Title: 17 UNIT DEVELOPMENT FOR AUSPRIME INVESTMENT GROUP P/L
20 RUFUS ST, BLACKWATER
SITE PLAN.

PLANS AND DOCUMENTS
referred to in the ULDA
APPROVAL dated 19/4/12

AMENDED IN RED
2 APR 2012
By: Matt Tuan (name)
of the ULDA

Title:
17 UNIT DEVELOPMENT FOR AUSPRIME
INVESTMENT GROUP P/L
20 RUFUS ST, BLACKWATER
ELEVATIONS UNITS 8-12. + 13-17

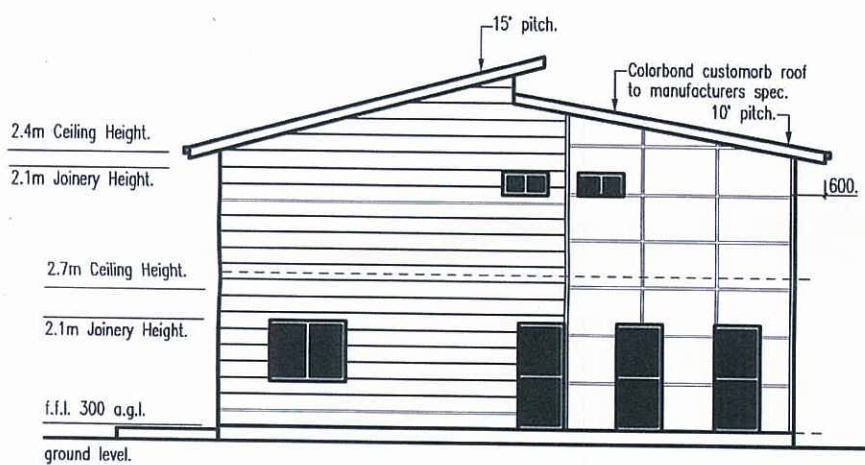
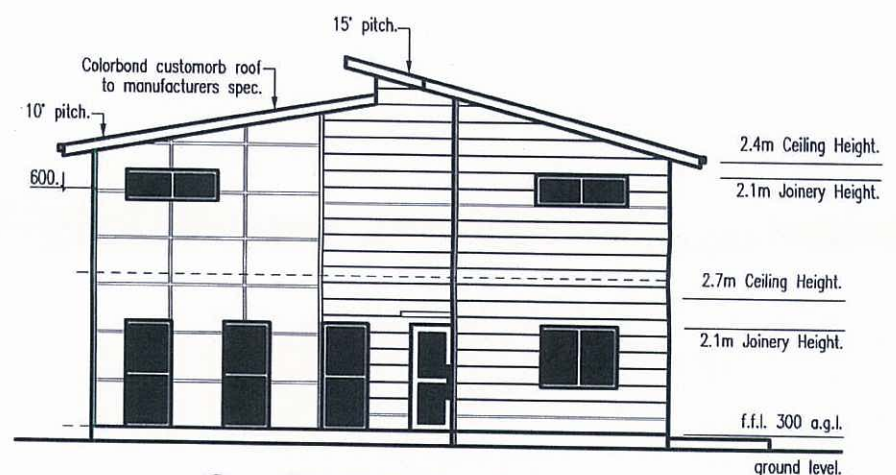
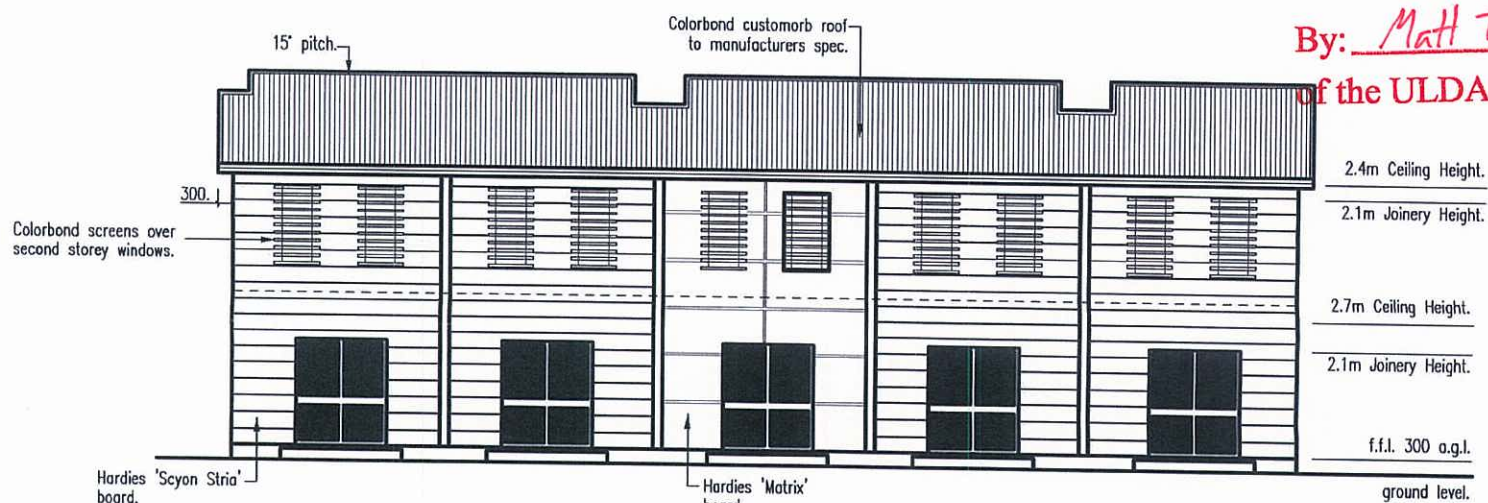
Refer to condition 4.
Entry to units must be further emphasised
with a permeable door or gates, outdoor
lighting and unit numbers.
